Questions:

Improvements to Make Project Technically Sound:

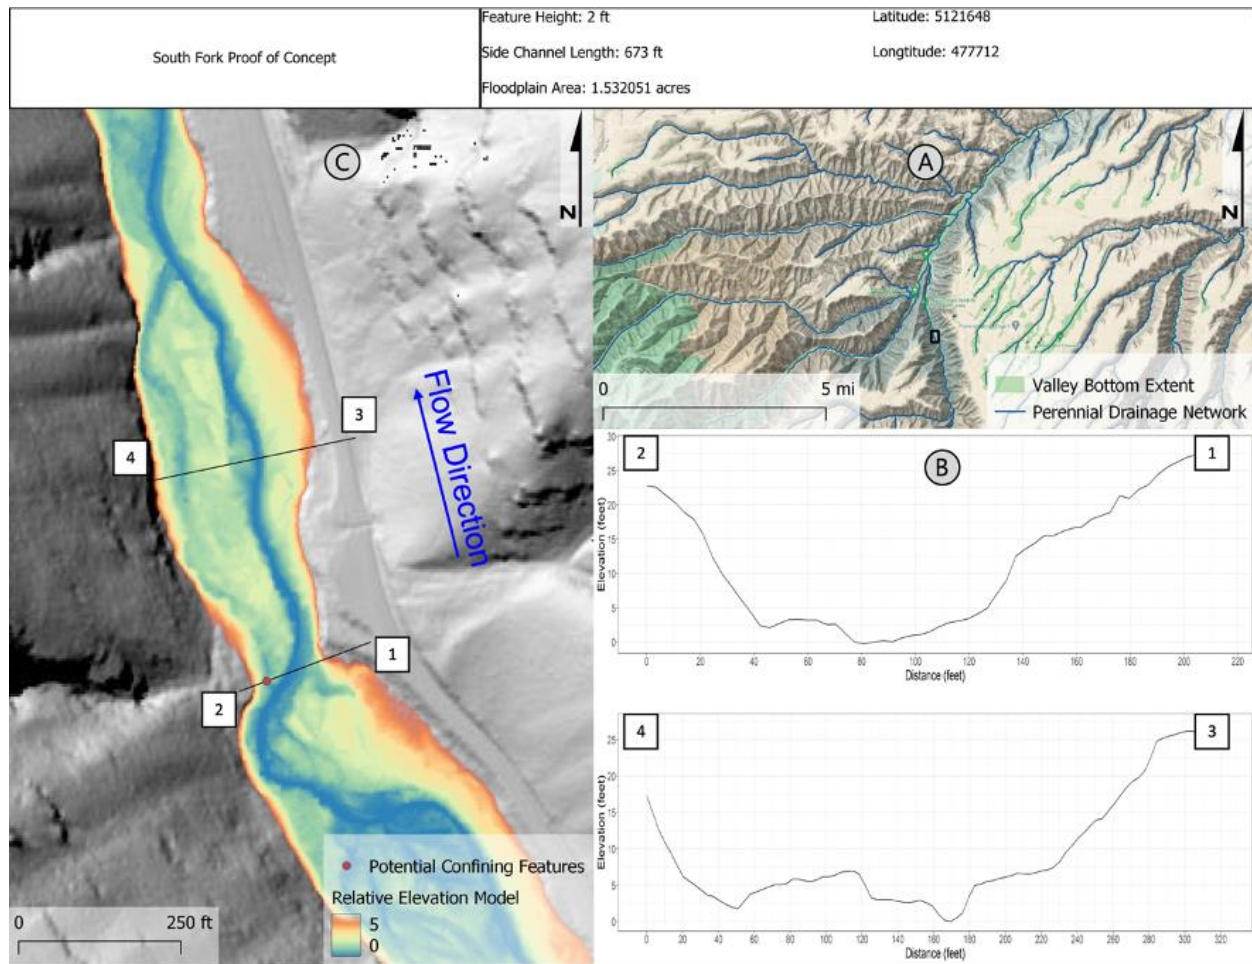
If there is a typical associated with this action or a description that provides details on the process, please include.

A typical depiction of what we are proposing is best described by the proof-of-concept site we visited on May 2 and the Basis of Design Report we provided in PRISM (page 11). In 2021-2022, we identified one confining berm through field observations in North Fork Asotin Creek. The berm was cutting off almost 700 feet of side-channel and 1.5 acres of floodplain habitat (Figure 1). We opened the berm at the head of historic side-channels by digging by hand and installed structures in the mainstem to back water up to the openings in the berms (Figure 2). However, it took several days with a crew of 3-5 to open the berm by hand digging and we could not fully open the berm (i.e., dig down the elevation of the mouth of the side-channel to the same elevation of the main channel) due to tree roots and large substrate (Figure 2). We propose to replicate this activity but use a mini excavator to speed up the process and allow us to dig deeper to connect the side-channels and floodplain at the same elevation as the existing active channel to allow the connection to persist at summer low-flows.
